# UNITED STATES PATENT AND TRADEMARK OFFICE

# Office Action Summary

10/575,673

WILLMANN, NIKO

FIGURE 1

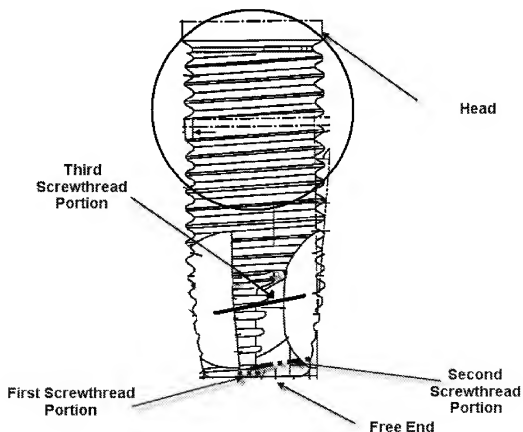
Jomeus discloses a bone screw having a screw head, shank and a thread formed on the screw shank of a plurality of turns characterized in that starting from the free end of the screw shank towards the head, a first screw thread portion with a smooth cutting edge extending toward the screw head, comprising three turns, a second screw thread portion extending from the first screw thread toward the screw head and is formed in its cutting edge with recesses. The recesses of the second screw

thread portion relative to the angular length in circumferential direction are increased compared to the second screw thread from the free end because the screw gets wider in diameter. There is also a third screw thread extending from the second screw thread, which has recesses. The second screw thread and in the third screw thread every 360 degrees three recesses are formed (see Figure 2). The recess extends as a chord toward the screw shank from the cutting edges of the second screw thread portion and of the third screw thread portion and joins in an arc again the cutting edge. The screw shank is considered to be in cylindrical and tapered form (see Figure 1 below).

The amendments filed on September 16, 2008 do not overcome the prior art. The definition of turns is not clearly defined. Each turn is interpreted by the examiner as every one degree of change with respect to a tangential line is considered a turn (e.g. one revolution of a screw has 360 turns). It is recommended that this term be further defined in the claim. It is also suggested to further define the recess. (i.e. Describing it in a way to explain that the thread has a certain width extending from a shaft of the screw, and the recess having a depth that does not reach the shaft and wherein the second and third screw portions have three recesses formed every 360 degrees.)
